IEEE P 802.20™/PD<insert PD Number>/V<7>

IEEE C802.20-03/81

Draft 802.20 Permanent Document

<802.20 Requirements Document >

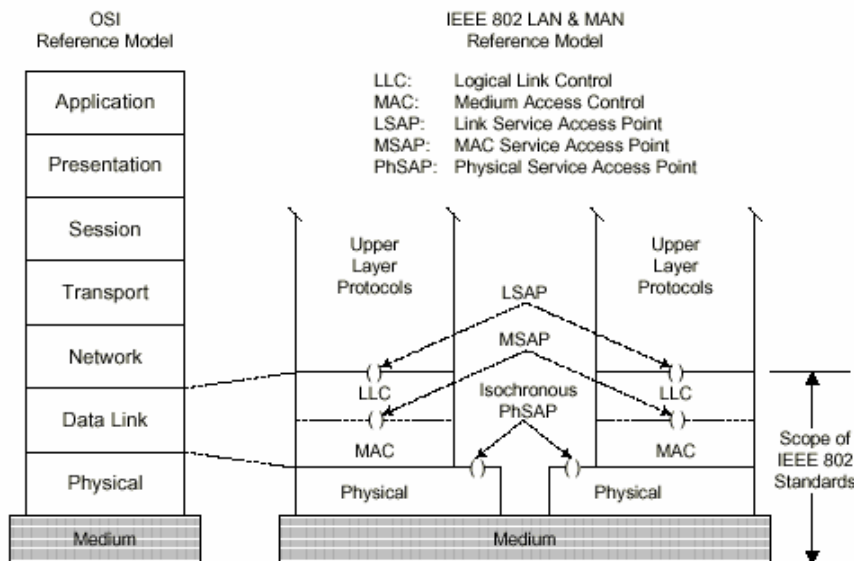
15 Editors Note Diagram in Appendix B

16 Action: Change the notations in the bubbles to point to the relevant
17 section of the text (or remove the bubbles). <John Fan 7/23/03>

MBWA-Specific Reference Model

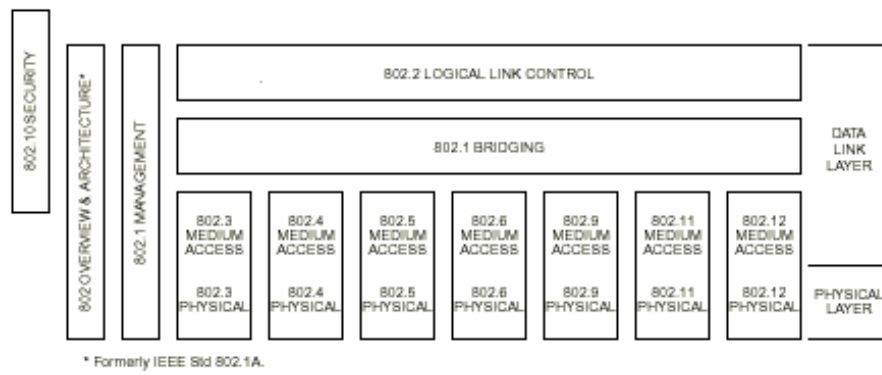
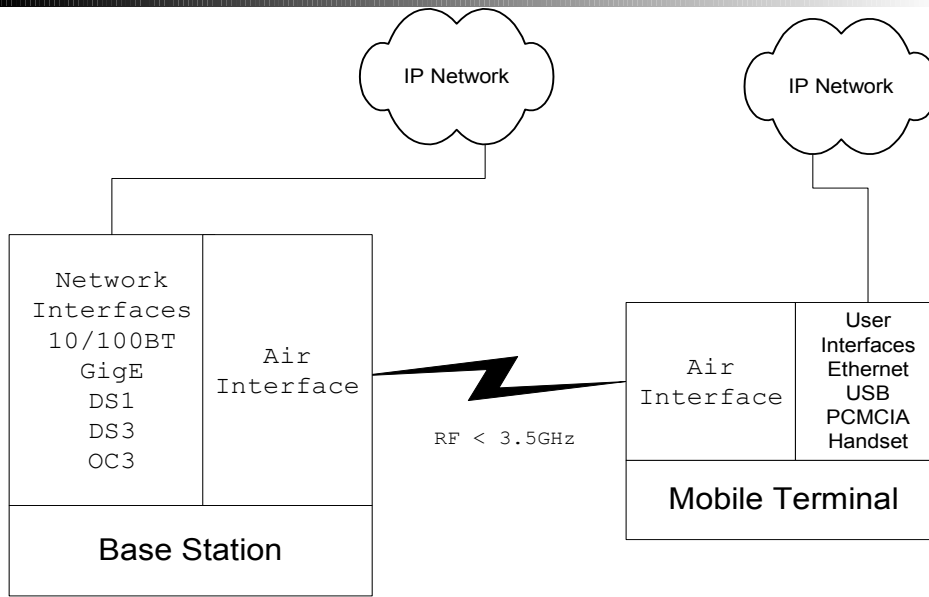
7 I propose to adopt the MBWA-Specific Reference Model and its
8 explanation from the attachment, that will replace 5.1.1.

9
10 Reasons for that are:

11
12 - 802.1 bridging, in Fig. 2, is actually beyond the standard;
13 including it in the standard scope will make the radio behave as a
14 Ethernet bridge and will have implications in frame headers (look at
15 802.11 MAC, carrying if I remember well, up to four Ethernet addresses
16 in the frame header);

17
18 - 802.1 Management, in Fig. 2 is actually insufficient for access
19 systems, being suitable only for LAN and WLAN systems;

20
21 - Security functions are not shown;

22
23 - Management functions and their interaction with
24 MAC/PHY/Security is not shown;

25
26 - PHY interaction with the radio deployment is not shown.
